STATE OF OHIO
DEPARTMENT OF TRANSPORTATION

POR-224/VAR-18.67/VAR

DEERFIELD & PALMYRA
PORTAGE COUNTY

RESURFACING OF US 224 FROM SLM 18.67 - 21.22, SR 14 FROM SLM 25.41 - 28.77, AND SR 225 FROM SLM 5.24 - 11.04 IN PORTAGE COUNTY. ADDITIONALLY, INCLUDES ODNR PARKING AREA WORK NEAR SLM 26.59. INCLUDES BRIDGE WORK TO FOUR STRUCTURES.

STRUCTURE DETAILS - CHANNEL CLEANOUT
LOCATION 4 - POR-225-8.967
SR 225 OVER BR KALE CREEK

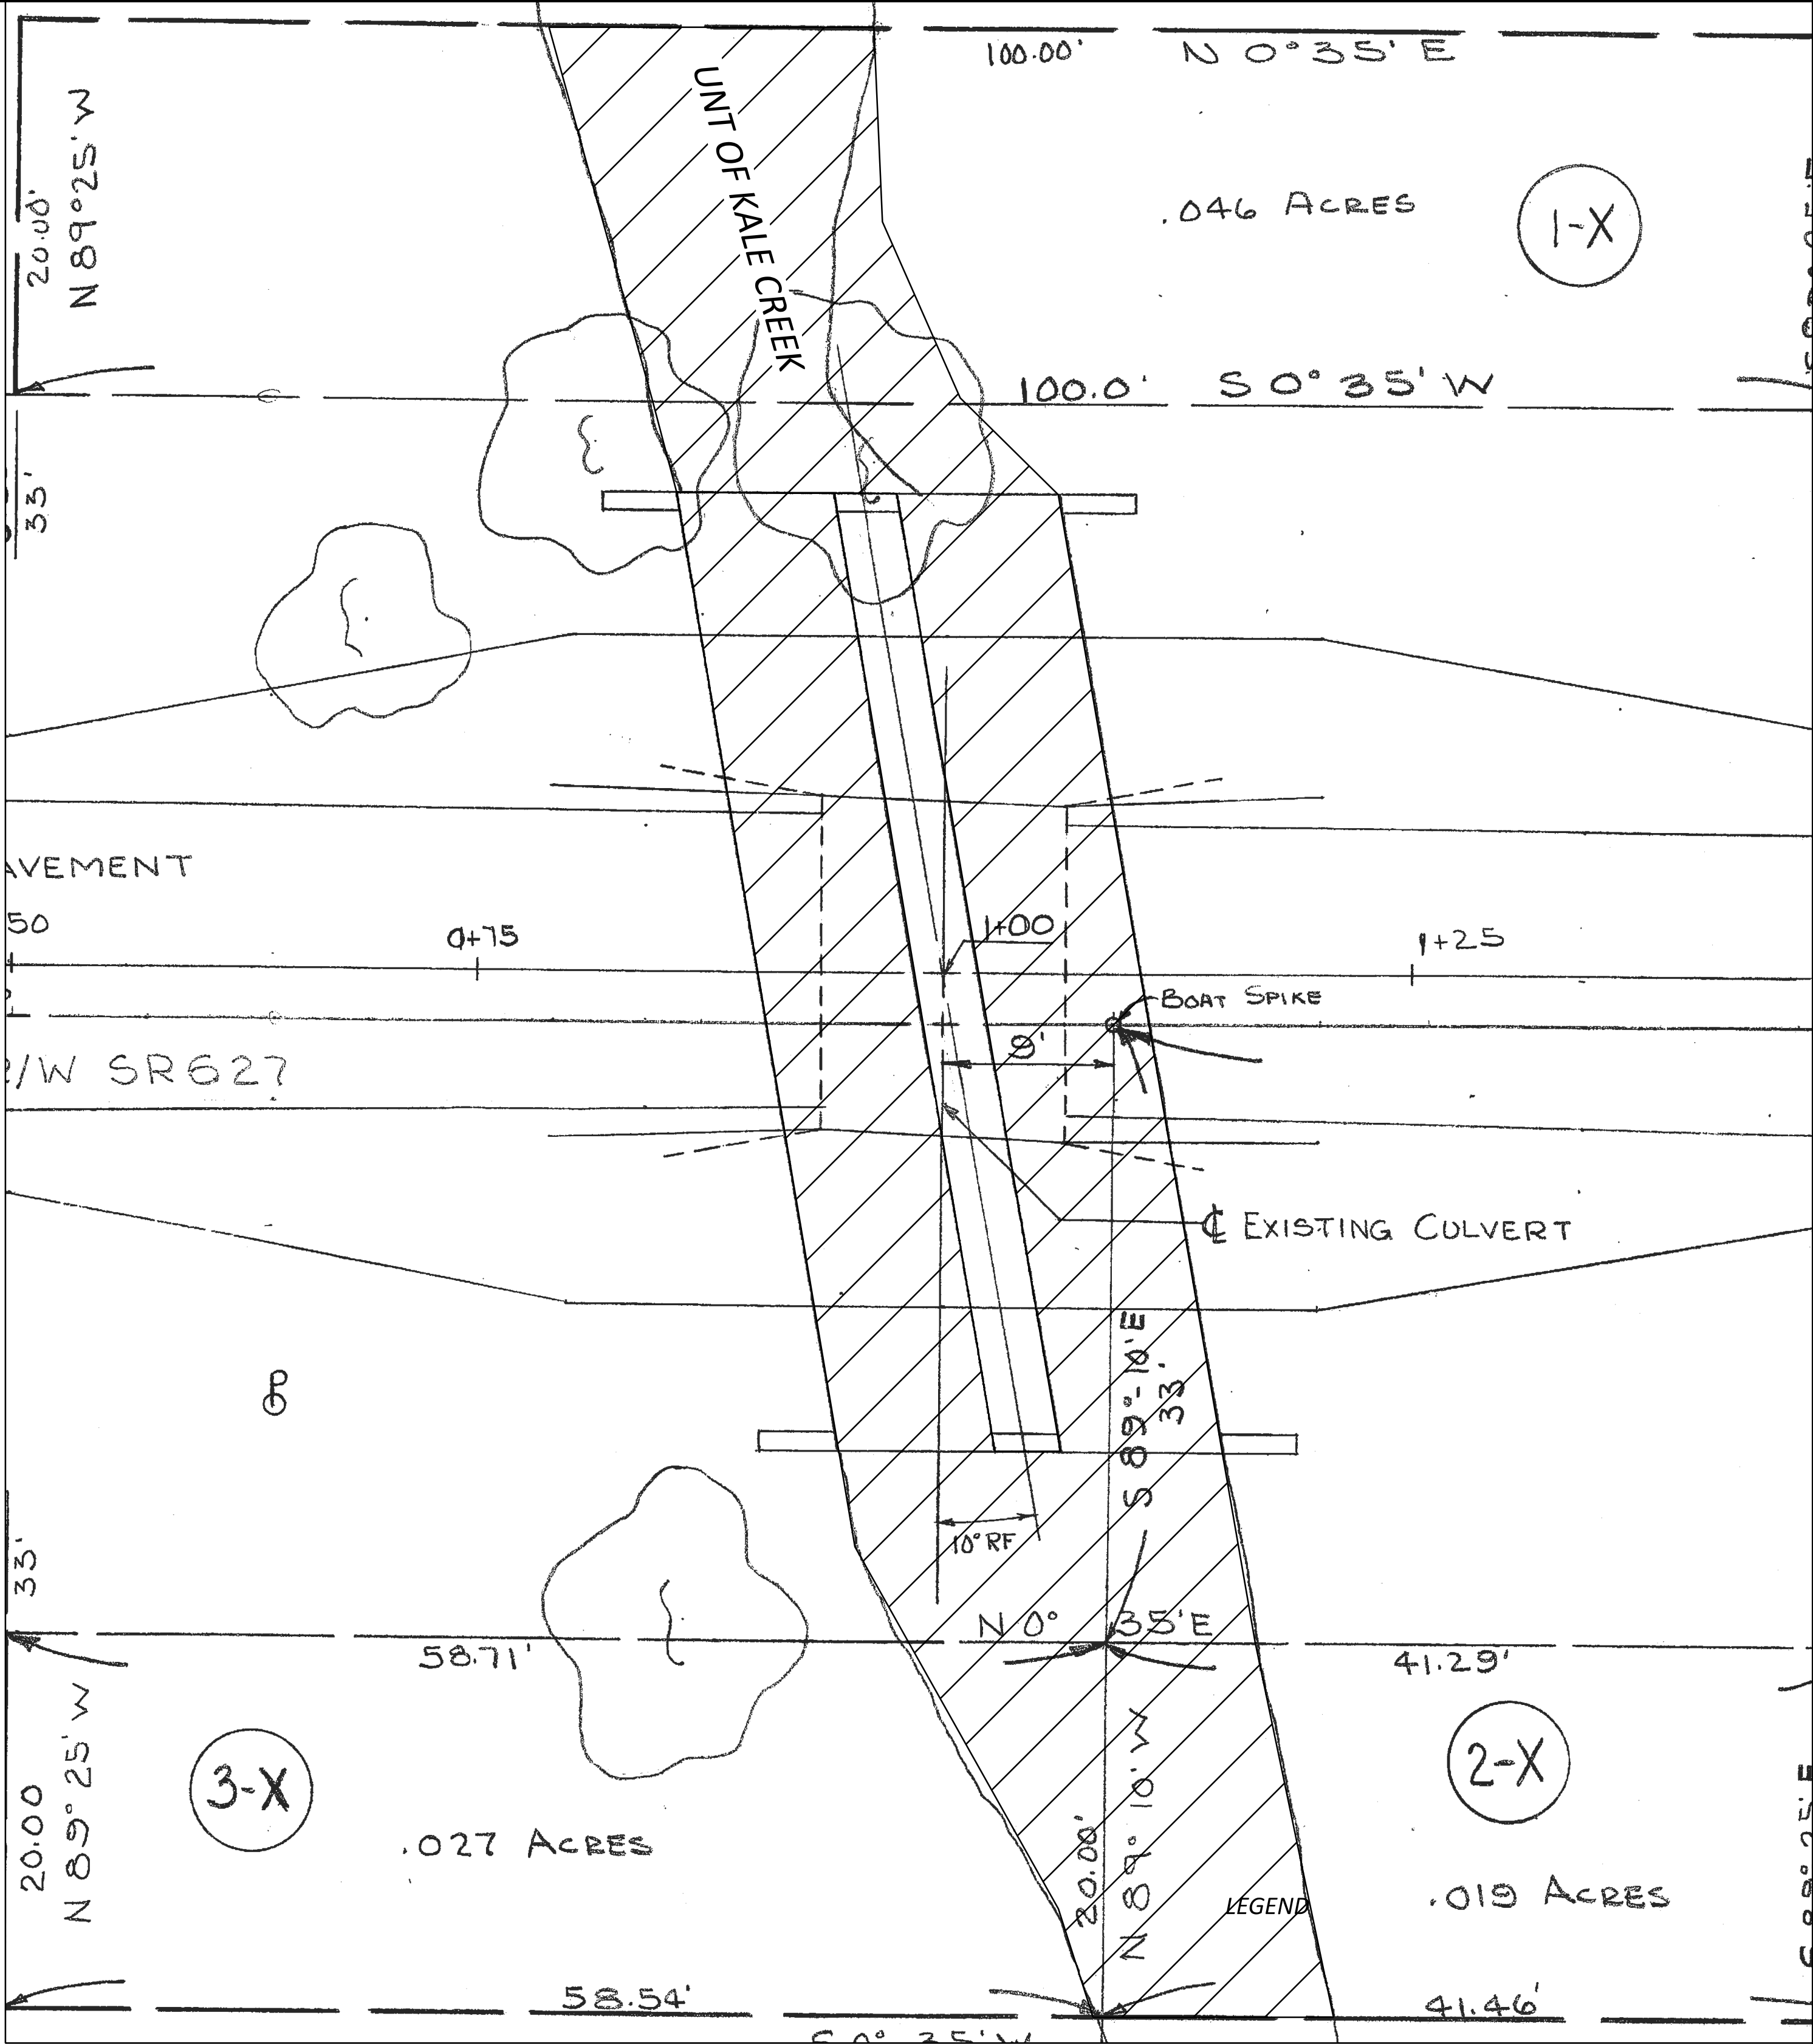
Estimated Quantities table has been revised to properly show work assigned.
No quantity changes.
